Construction Change Directive

PROJECT: *(name and address)*
Highland Township Fire Station 2
PIA #18-122B

CCD INFORMATION:
Directive Number: 001
Date: July 13, 2021

“EXHIBIT A” – CCD NO. 1

A3-10 ENLARGED FLOOR PLANS

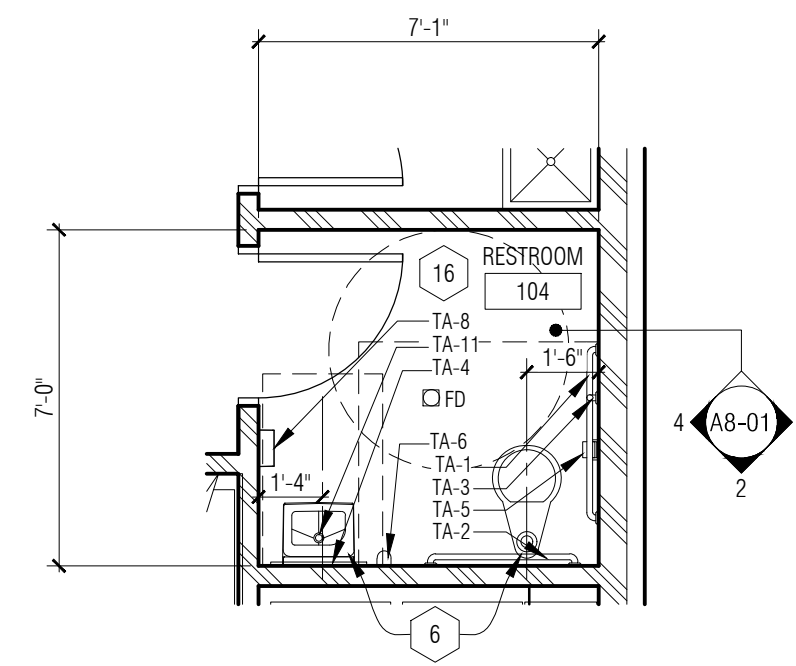
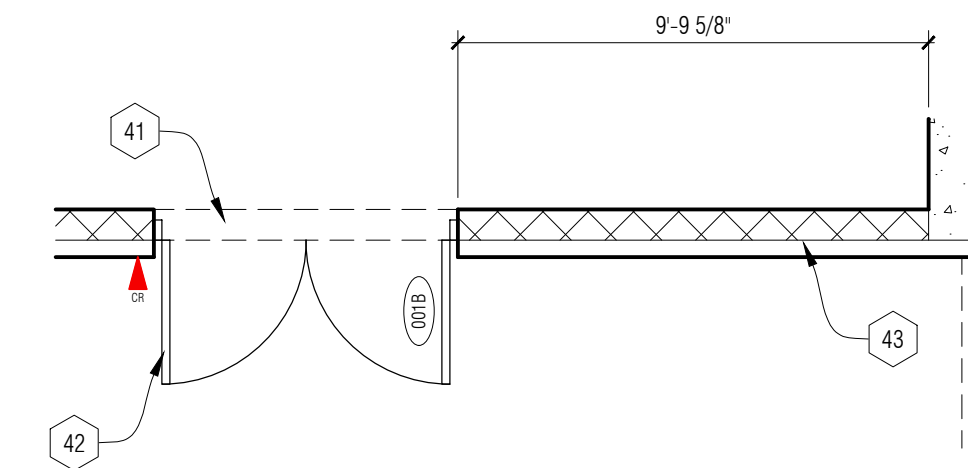
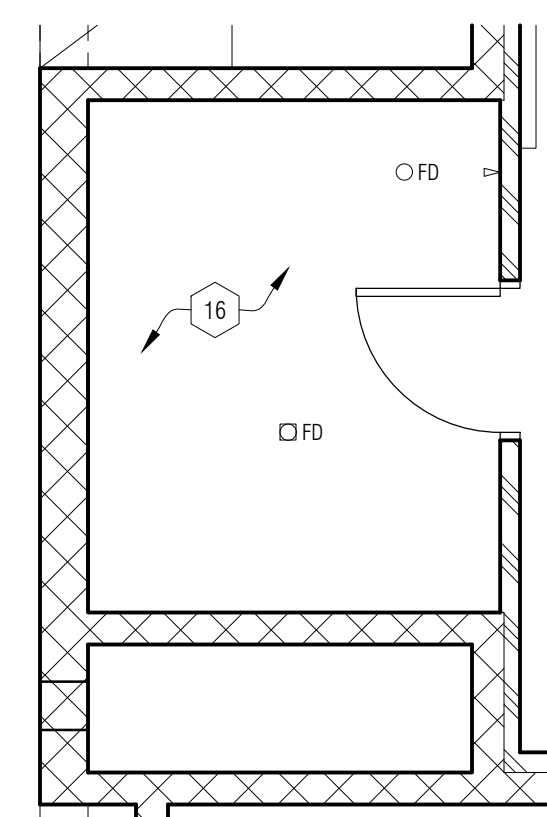
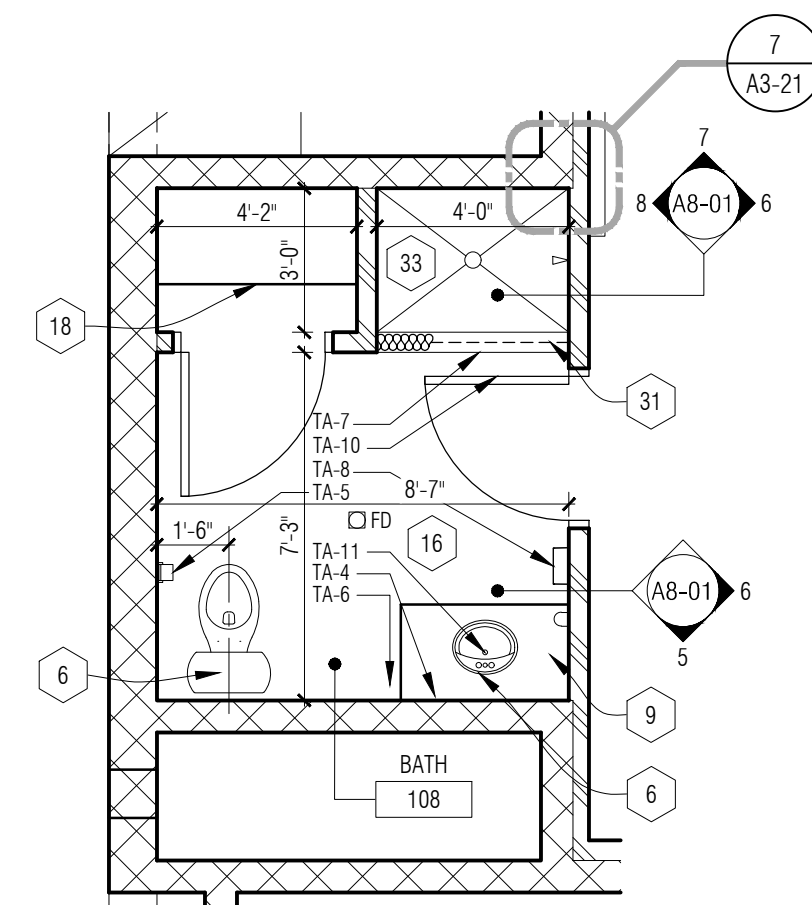
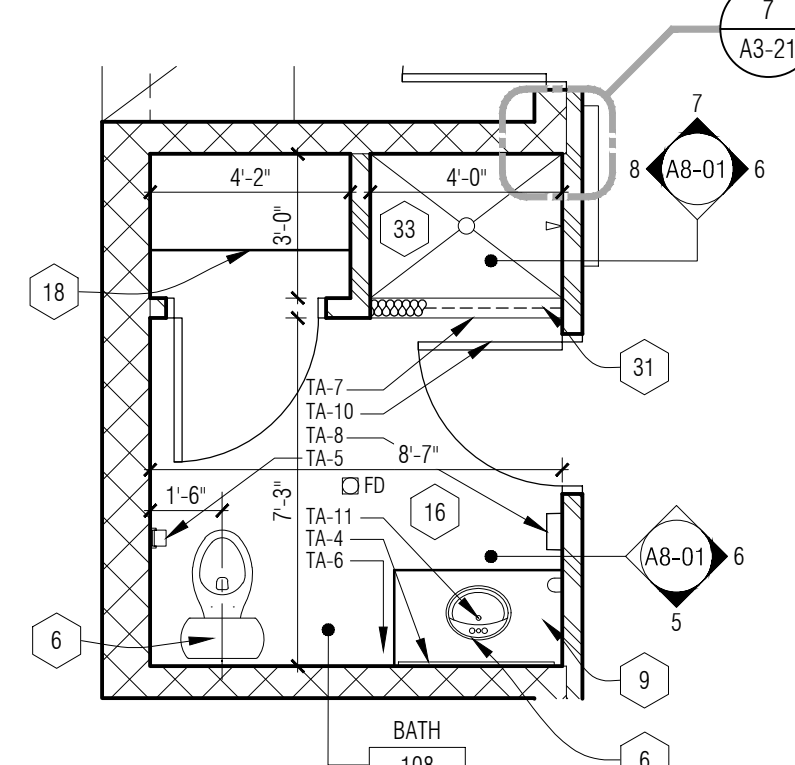
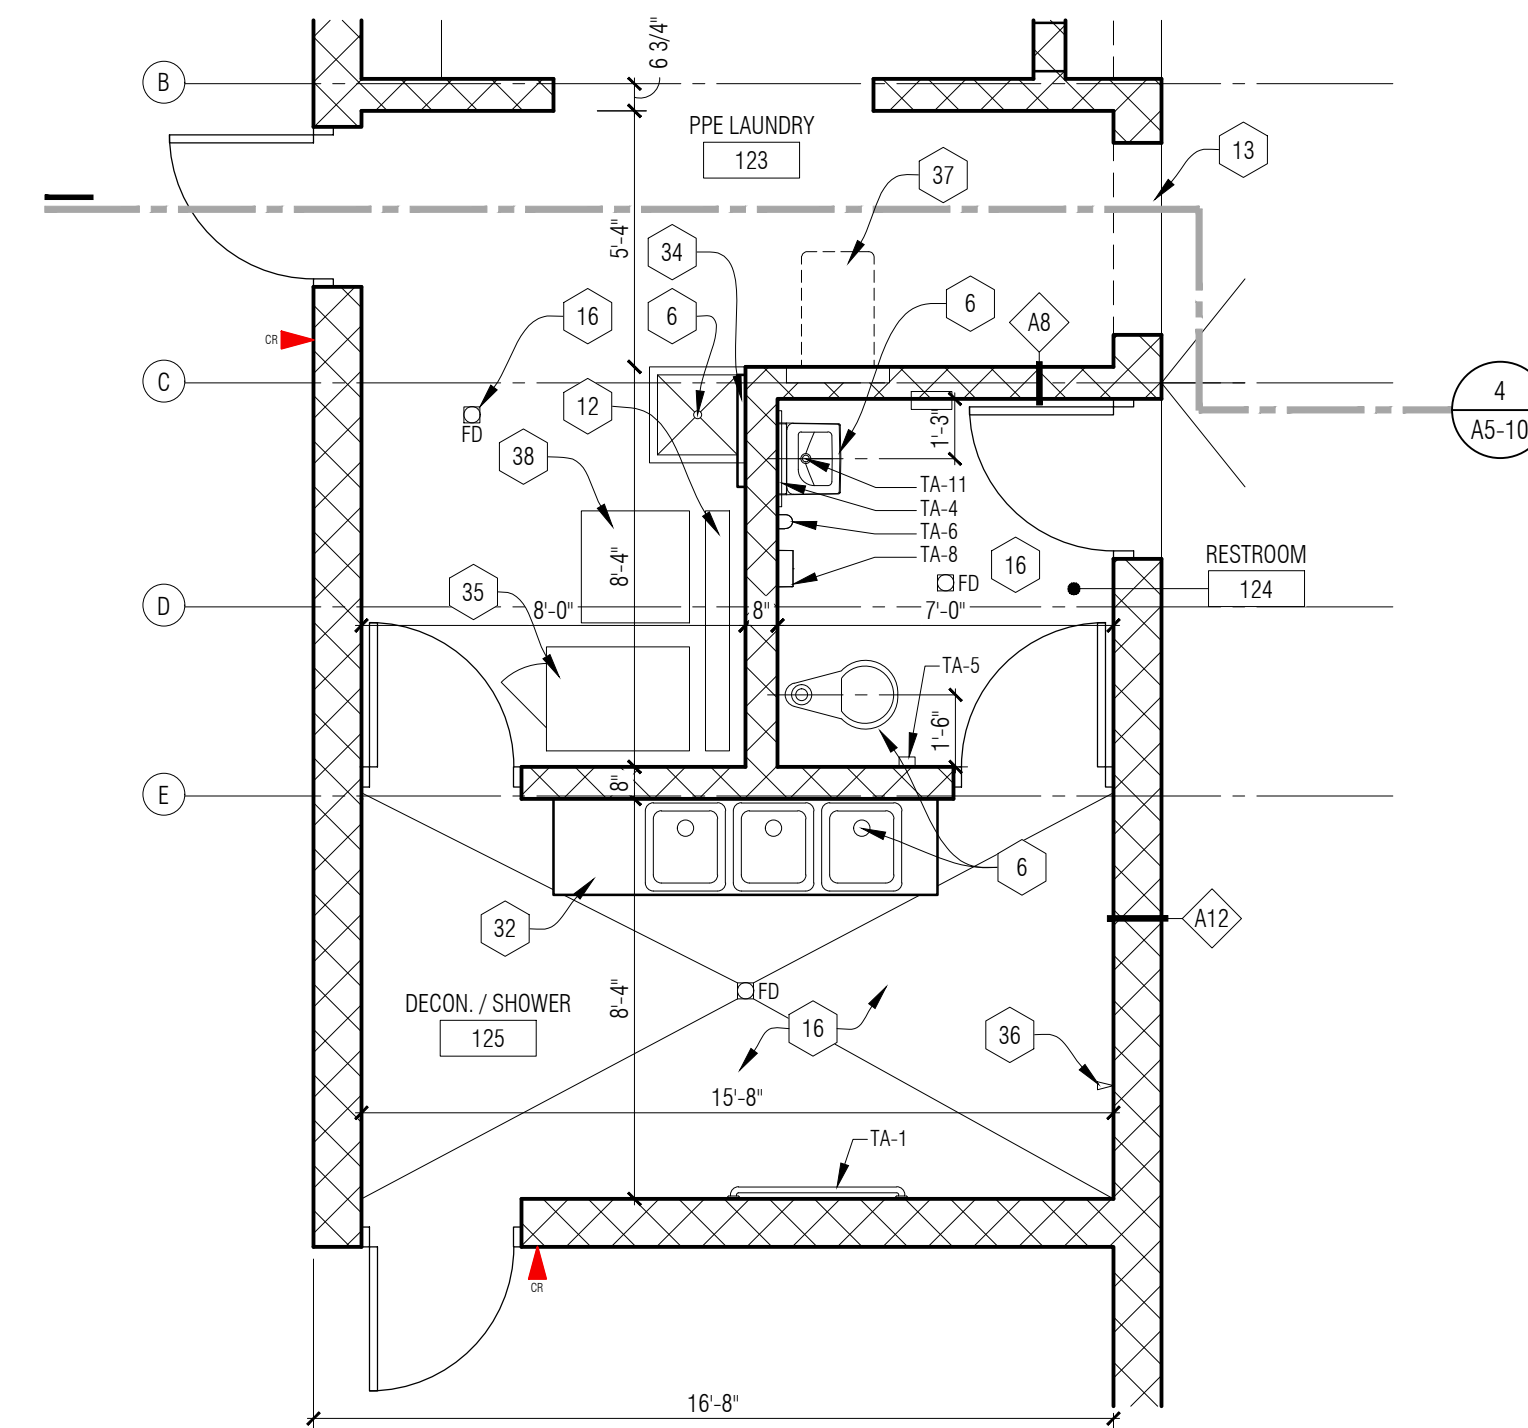
- A. Add mirror size (24" x 36") to Item TA-4 in the Toilet Accessories Legend.

8 Plan Detail
A3-01 1 1/2" = 1'-0"

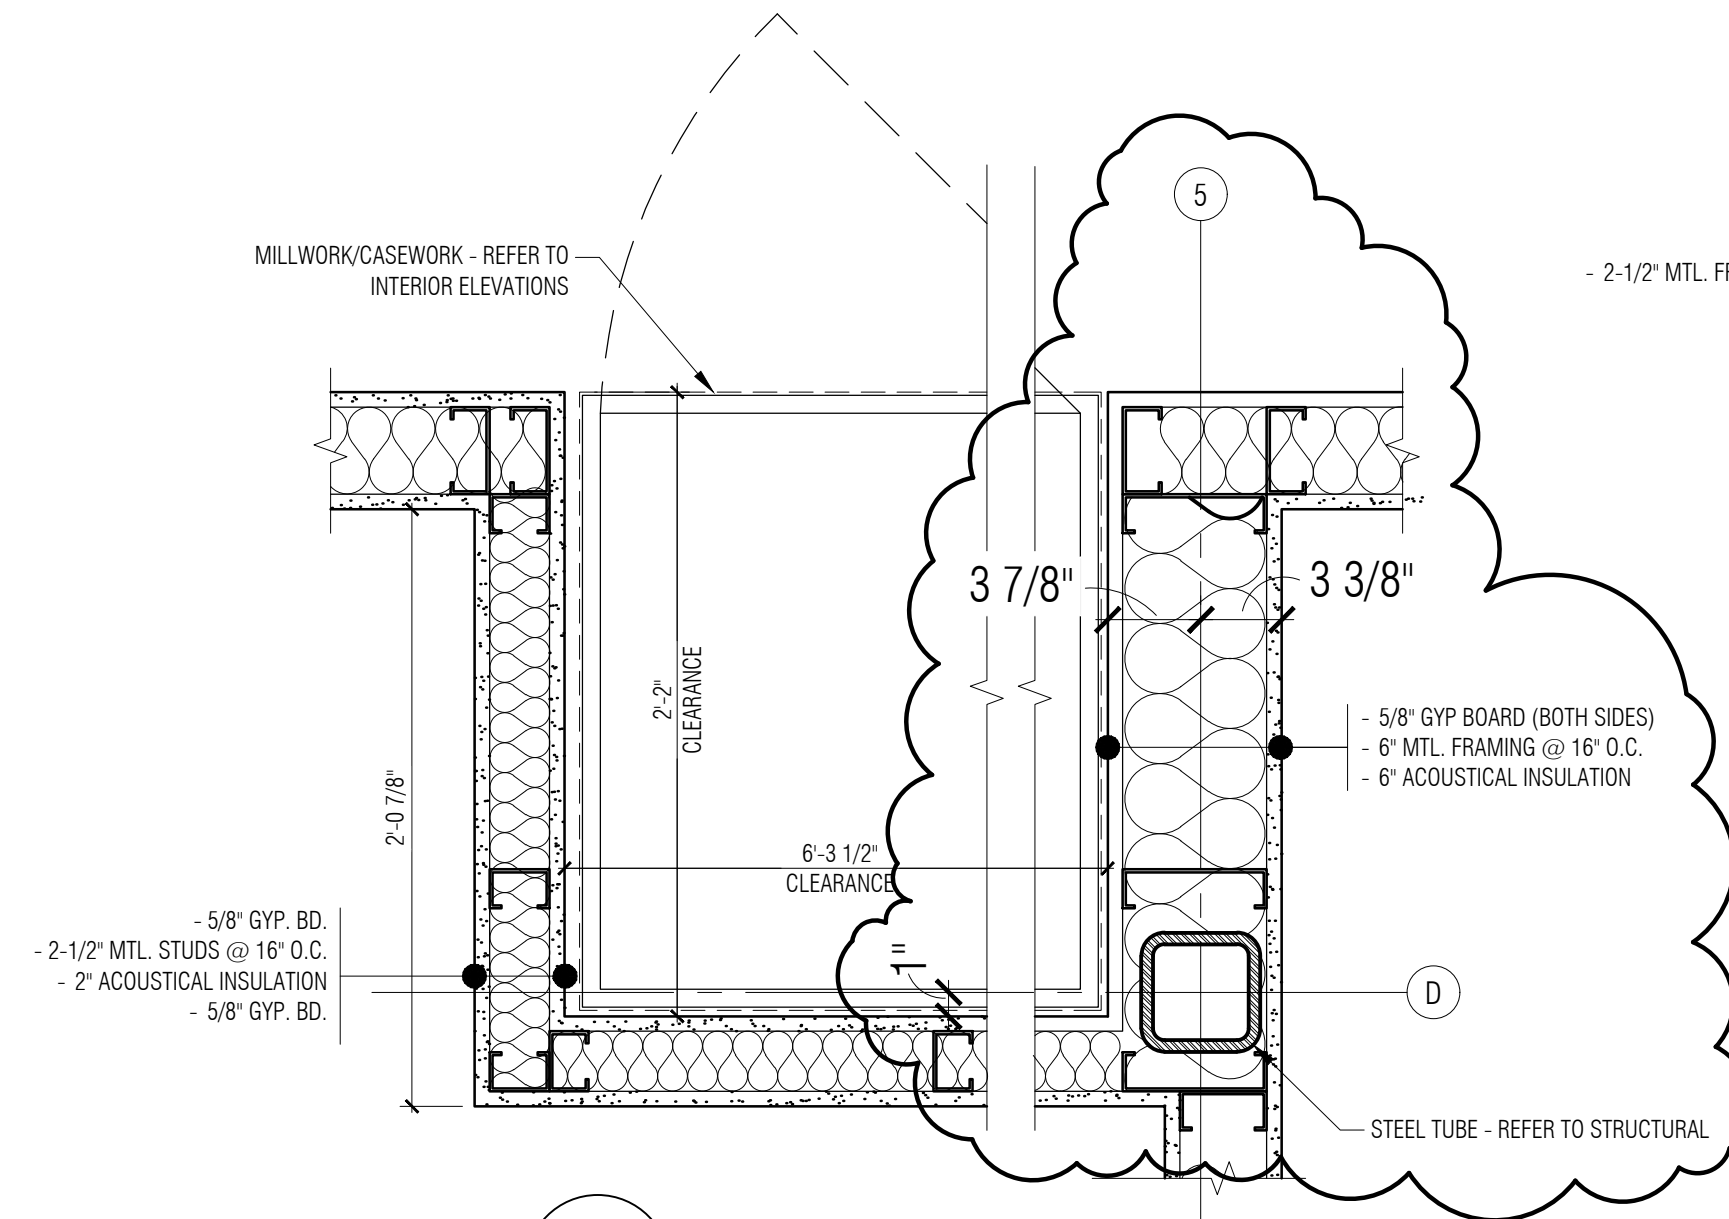
- A. Add column D5 to Plan Detail 8/A3-01.
- B. Revise dimensions of partition at new column location and change metal stud size from 3 5/8" to 6".
